10 REMARKS

24 The drawings are objected to because it is unclear what reference number 1192 in Figure 11 is
25 pointing to. Applicants propose to add a symbol of video content to which the reference number will
26 point. The symbol of video content corresponds to that used in Figures 9 and 12 with the same
27 reference number 1192. Applicants request that the Examiner approve the proposed addition. In the
28 event the Examiner approves the proposed addition, a clean corrected drawing sheet of Figure 11 is
29 also submitted with this amendment.

MARKED-UP VERSION OF THE AMENDMENTS

FIG. 12

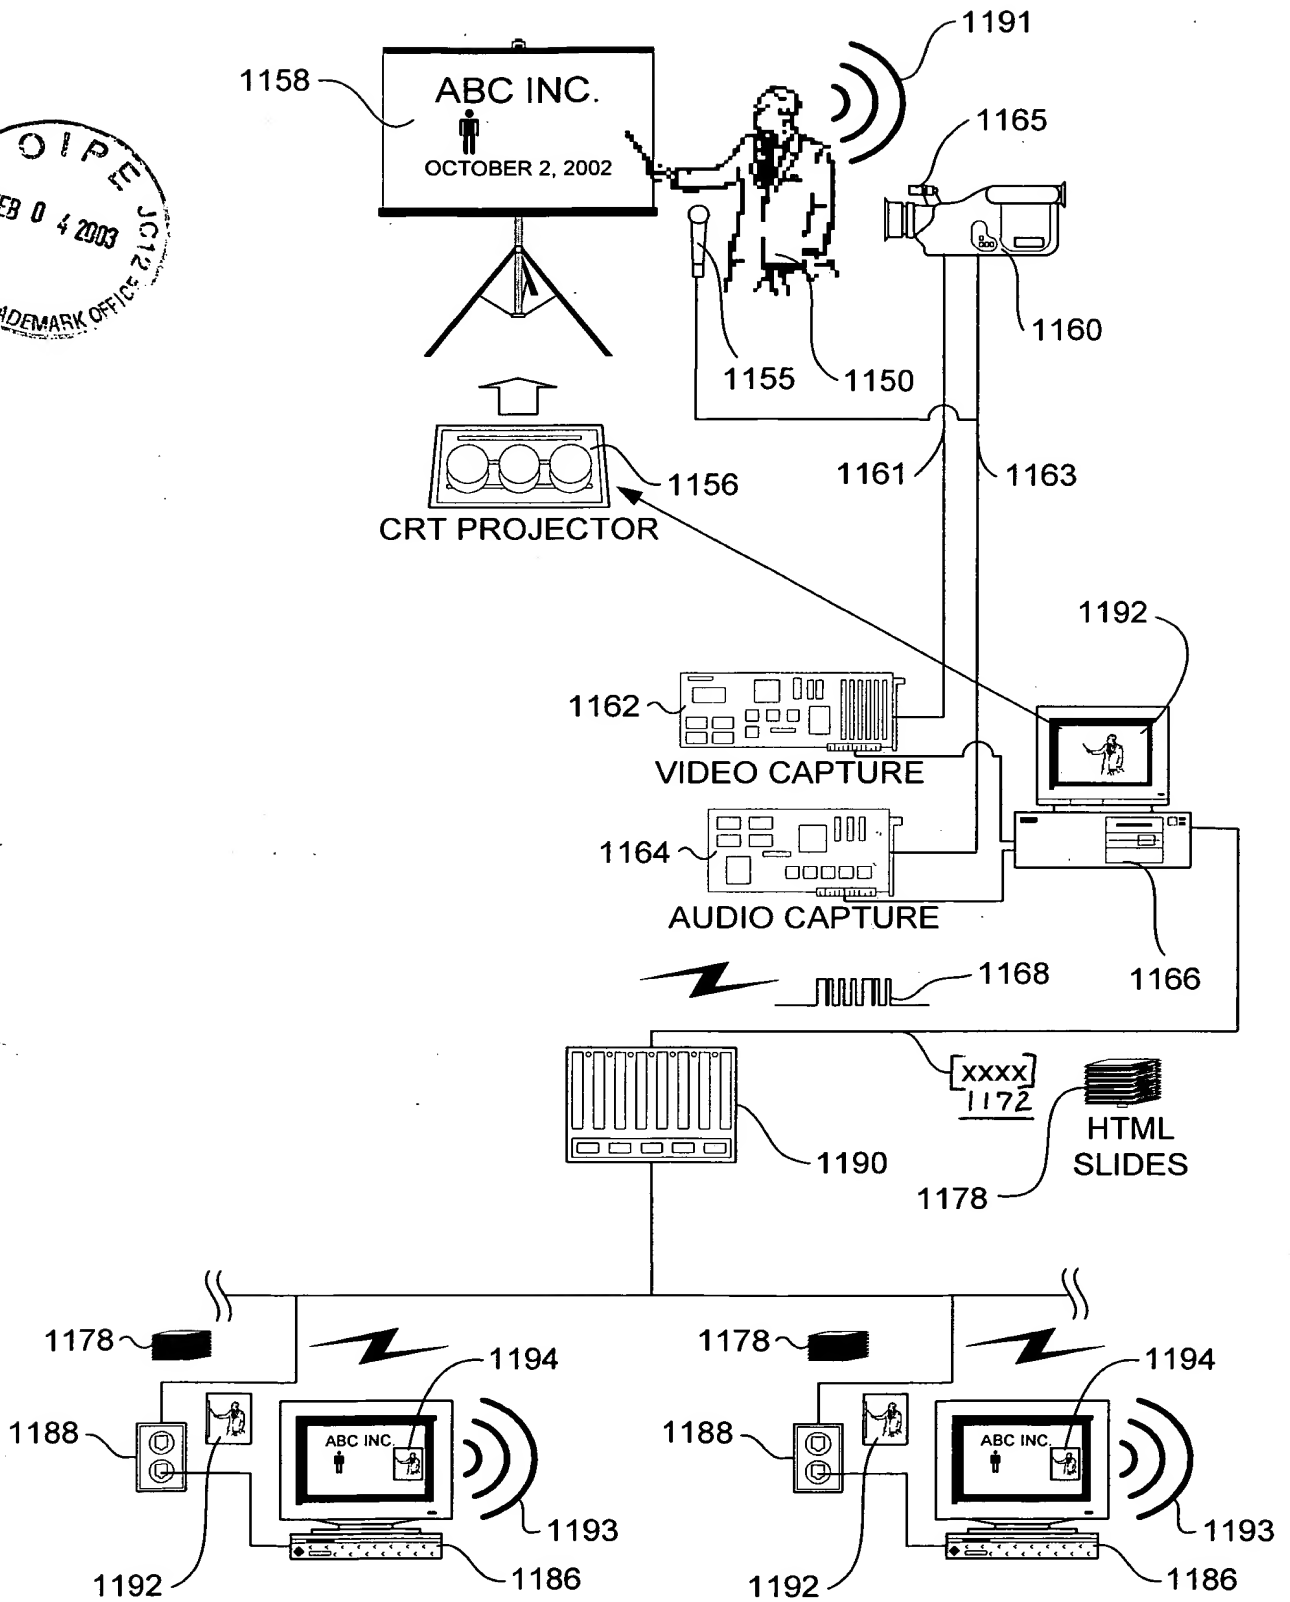
30 The drawings are also objected to because Figure 12 includes a reference "xxxx." Applicants
31 propose to replace "xxxx" with the reference number 1172, corresponding to a network
32 communication channel, similar to that shown in Figure 9. Applicants request that the Examiner
33 approve the proposed replacement. In the event the Examiner approves the proposed replacement, a
34 clean corrected drawing sheet of Figure 12 is also submitted with this amendment.

24 Please amend Figures 11 and 12 as indicated in red ink in the enclosed corrected drawings.
25 Clean copies of Figures 11 and 12 are submitted with this amendment in the event the Examiner
26 approves the corrections to the drawings.
